No. EC155-04A014

ALERT SERVICE BULLETIN

LIMITATIONS - Control rod double bearing Tail Gearbox (TGB)

The purpose of revision 7 of this ALERT SERVICE BULLETIN is to allow the pilot to do the periodic inspection of the magnetic plugs.

Figure 1: Example of abrasion on the magnetic plug

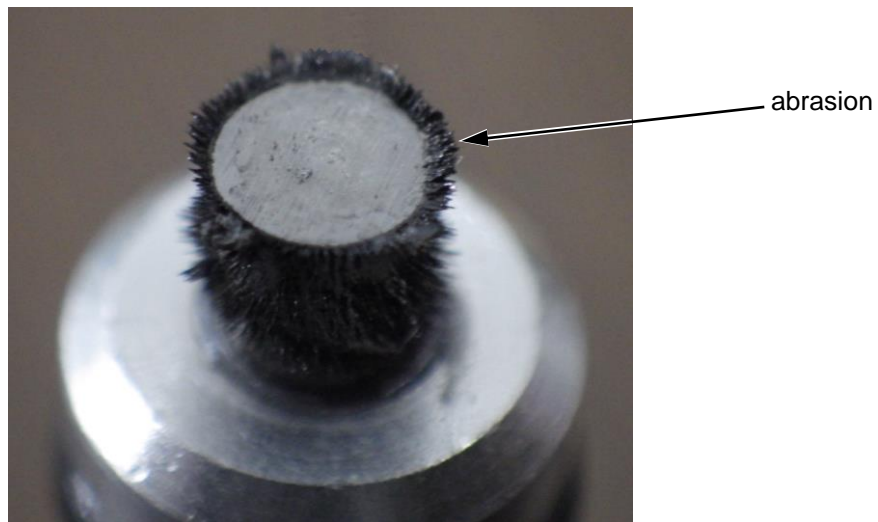
IN THE FLOW CHART, THE ABRASION PARTICLES (CLASS g AS PER MTC) MUST BE TAKEN INTO ACCOUNT IN ADDITION TO THE PARTICLE TYPES USUALLY TAKEN INTO ACCOUNT.

Are there **abrasion** (as per example in Figure 1)/scale/chip/splinter type particles or particles different from cotter pins, lockwire, swarf, various non-metallic debris ?**

Figure 2

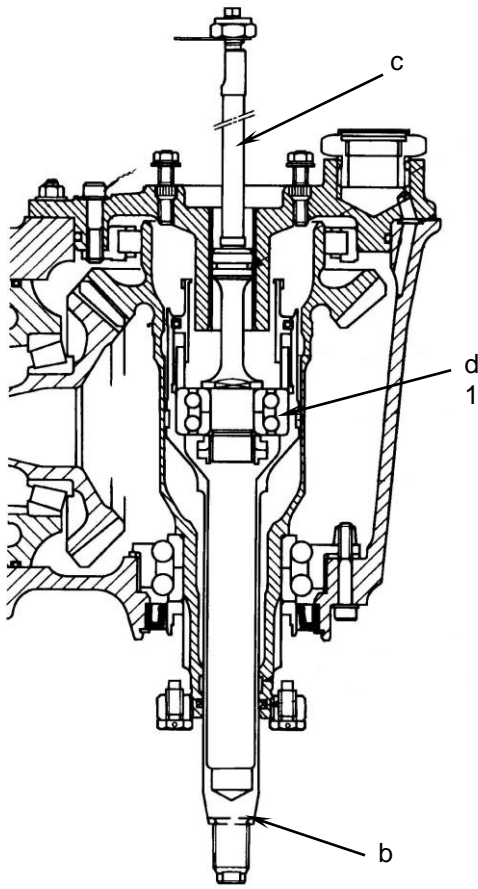
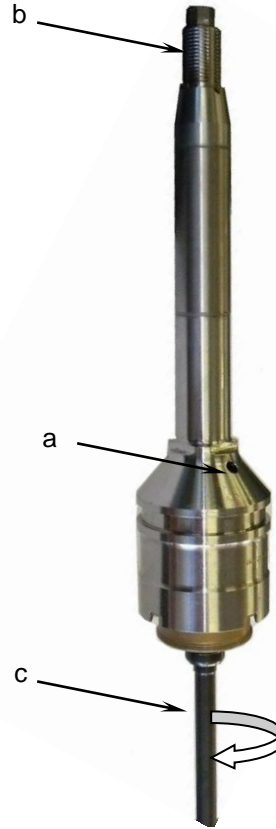
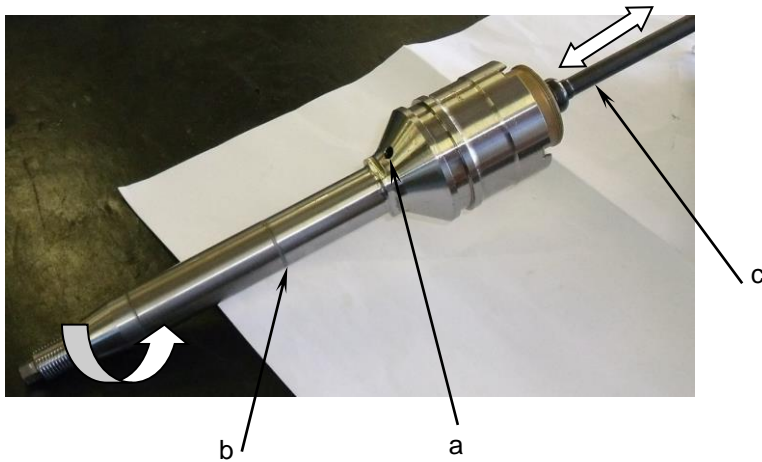
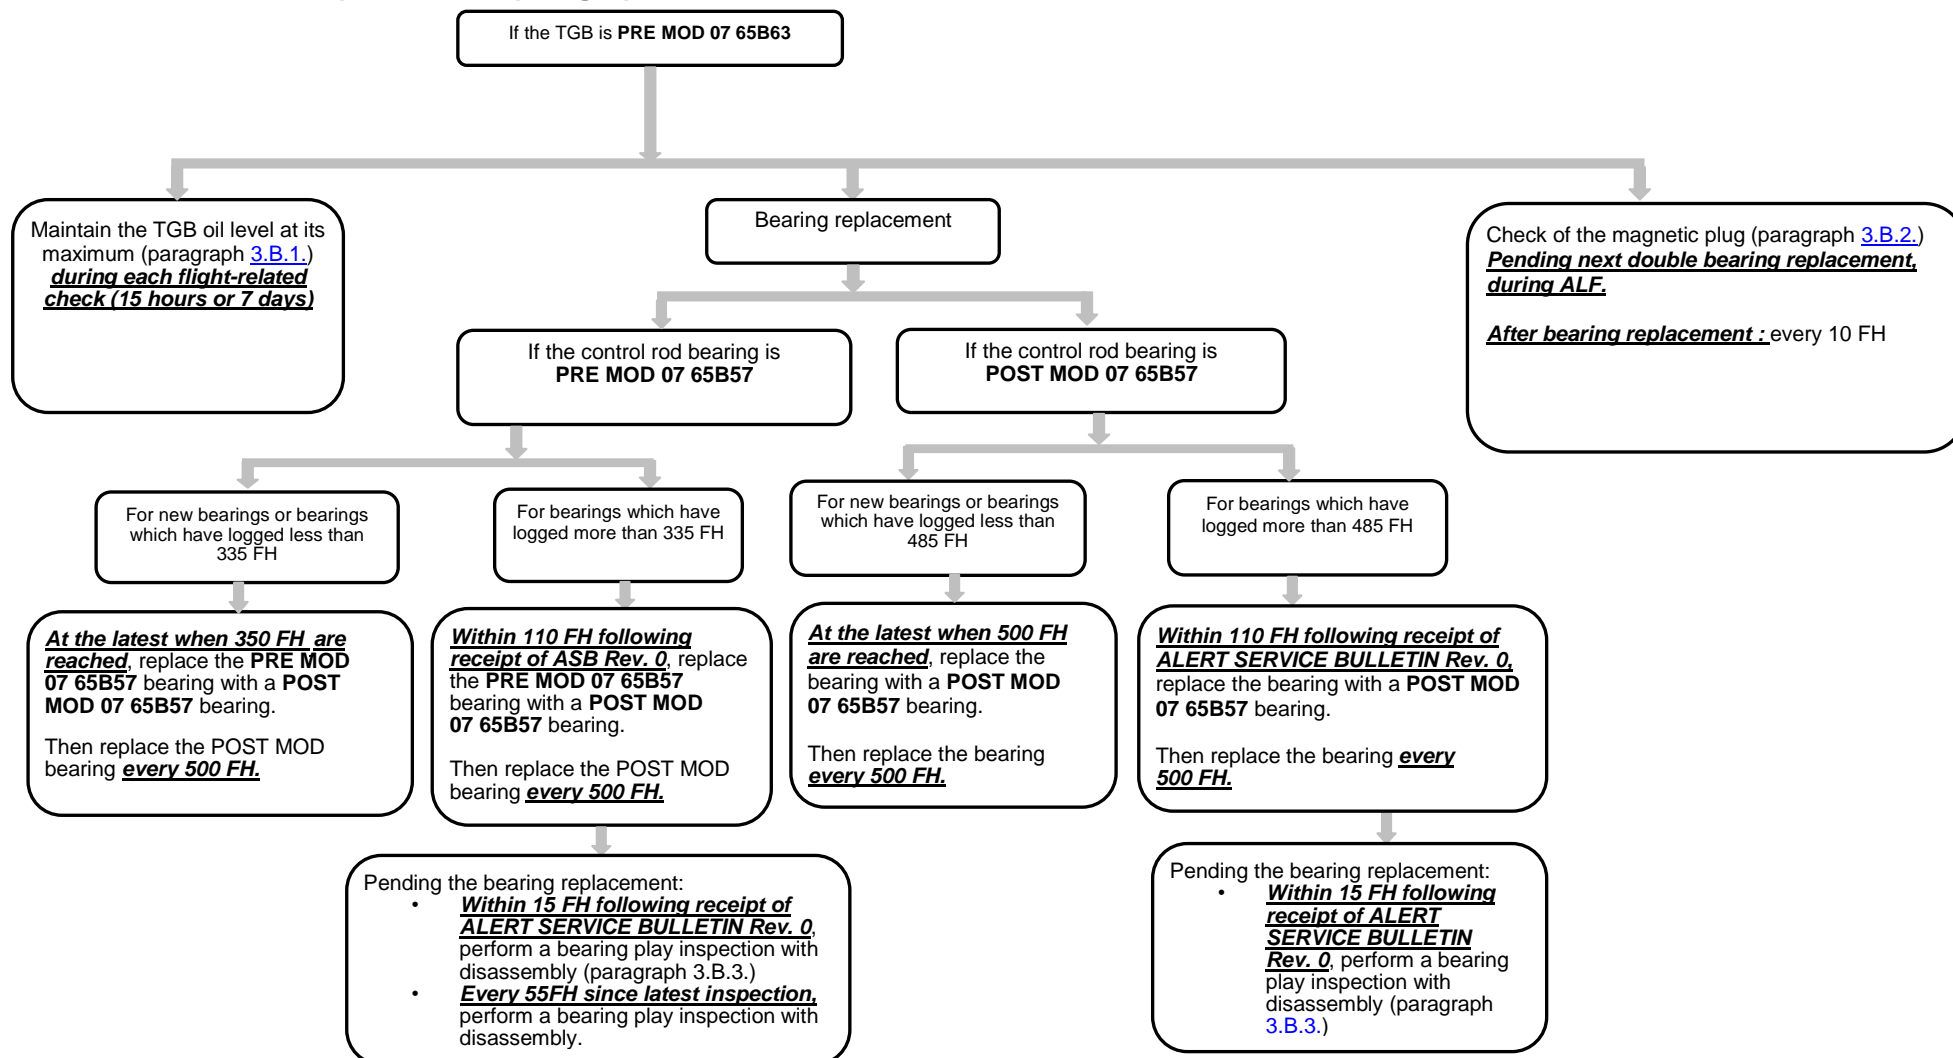
- Remove the control shaft/rod assembly as per paragraph 3.B.4.a.
- Carry out a tactile check to ensure that there is no axial play in double bearing (d) (Figure 1):
 - . Apply an alternating manual axial load to control rod (c) whilst turning control shaft (b) (**See [DETAIL A Figure 2](#)**).

- Clean the control shaft/rod assembly using WHITE SPIRIT (2) as per Work Card 20-04-01-102 (MTC):
 - 1) Inject WHITE SPIRIT (2) under pressure (for example using a can) into hole (a) of control shaft (b). (**See [DETAIL B Figure 2](#)**).

- . Hold shaft (b) in the vertical position pointing upwards.
 - . Manually turn control rod (c) several times to rinse double bearing (d) by draining the WHITE SPIRIT (2) through the bearing. (**See [Detail B Figure 2](#)**).

- 2) Insert WHITE SPIRIT (2) (for example using a can) in the area of the control shaft (b) that must be cleaned. (**See [DETAIL C Figure 2](#)**).
 - . Manually turn the control rod (c) several times to wash the double bearing (d) by draining the WHITE SPIRIT (2).

Make sure that the area pointed out in [DETAIL C Figure 2](#) is clean.

As double bearing (d) is "pre-stressed" by definition, friction points can be felt when turning double bearing (d): they are not critical.
